Access Compliance Report Public Rights-of-Way (Curb Ramps)

Intersection ID: 19817 Main Street: MONROE_RD Cross Street: TIMBER_SPRINGS_DR Location: NW

ADA ID: 2ED2D49587F4 Ramp Type: Perp Initial Pass/Fail: Fail Overall Compliance: No Severity Score: 12.5

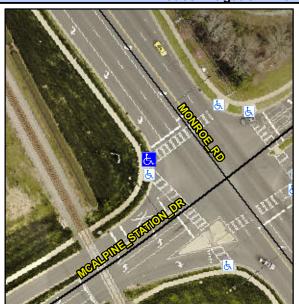
Field Measurements/Component Compliance						
Compliance Description		Data	Comp	oliance Description	Data	
N/A	Ramp Length (in)	96.0	No	Ramp Slope (%)	8.8	
Yes	Ramp Width (in)	48.0	Yes	Ramp XSlope (%)	0.0	
N/A	Flare Type LT	N/A	N/A	Flare Type RT	N/A	
N/A	Flare Slope LT (%)	N/A	N/A	Flare Slope RT (%)	N/A	
N/A	Flare Traversable LT?	N/A	N/A	Flare Traversable RT?	N/A	
N/A	Landing Length (in)	N/A	N/A	DWS Provided?	N/A	
N/A	Landing Width (in)	N/A	N/A	DWS Contrast?	N/A	
N/A	Landing Slope (%)	N/A	N/A	DWS Length (in)	N/A	
N/A	Landing X Slope (%)	N/A	N/A	DWS Full Width?	N/A	
N/A	Landing Curb? (Y/N)	N/A	N/A	DWS Offset (in)	N/A	
N/A	Shared Landing?	N/A				
N/A	Gutter Ponding?	N/A	N/A	Gutter Slope (%)	N/A	
N/A	Gutter Lip Ht (in)	N/A	N/A	Gutter X Slope (%)	N/A	
N/A	Painted X Walk1?	Yes	N/A	Painted X Walk2?	N/A	
	X Walk 1 Direction	To NE		X Walk 2 Direction	N/A	
N/A	X Walk 1 Width (in)	113.0	N/A	X Walk 2 Width (in)	N/A	
	X Walk 1 Slope (%)	0.7		X Walk 2 Slope (%)	N/A

Possible Solutions:
Remove & Replace Entire Ramp.
Surveyor Notes: N/A
PROW/ADA: R304.2.2
